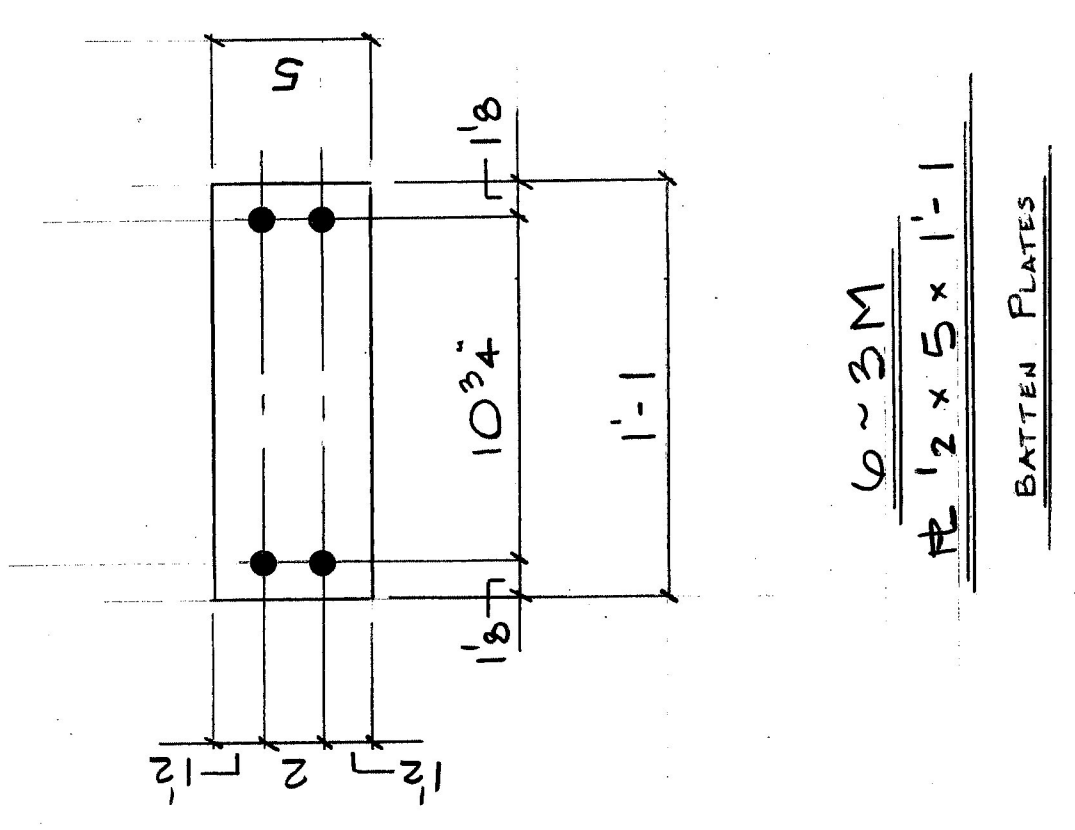
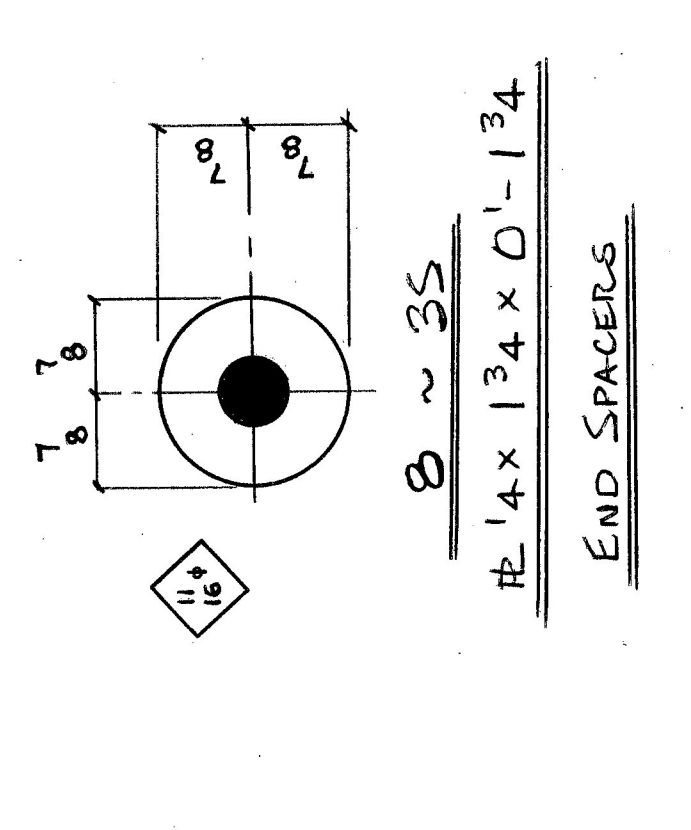
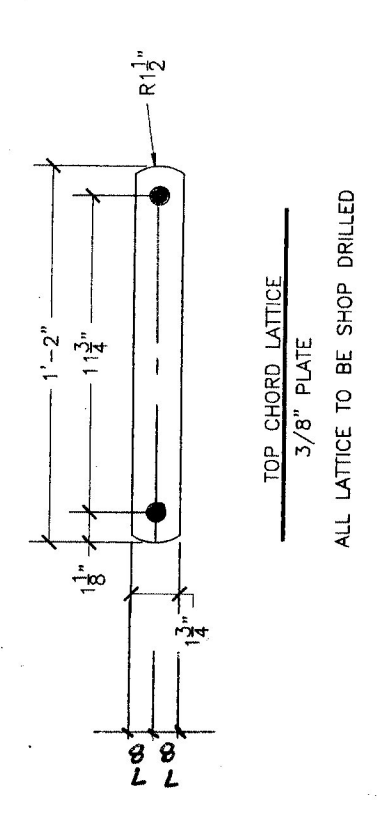
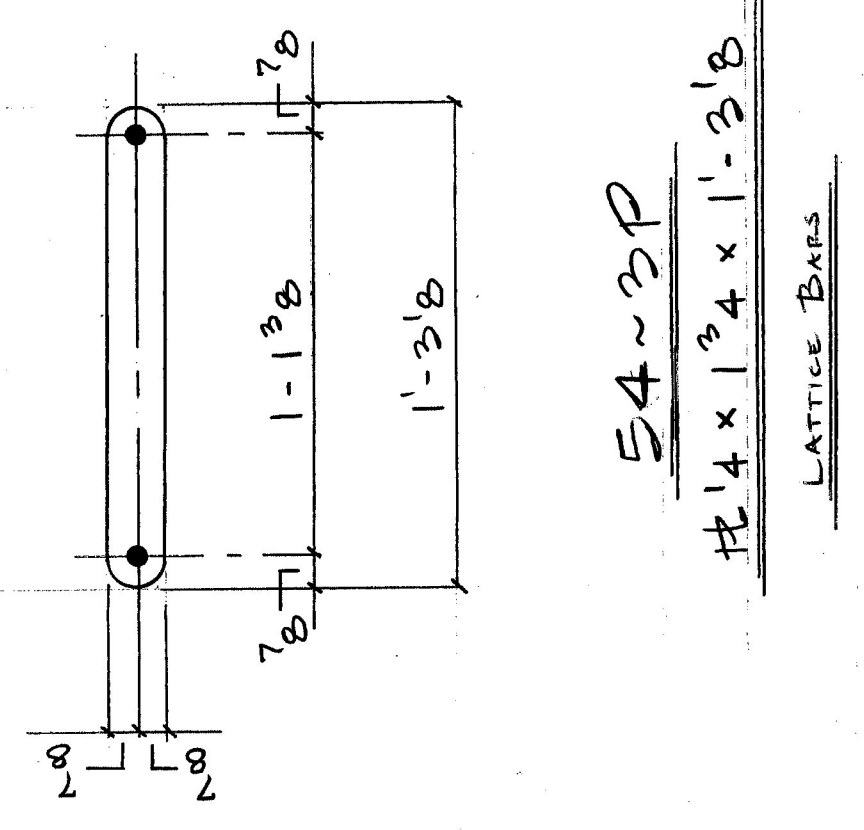
The replacement of members EPI, U1-U2, U2-U1, and EPI necessitates different details than shown on this sheet. See Sheets 10-13 (1/4-4/4) for modifications.
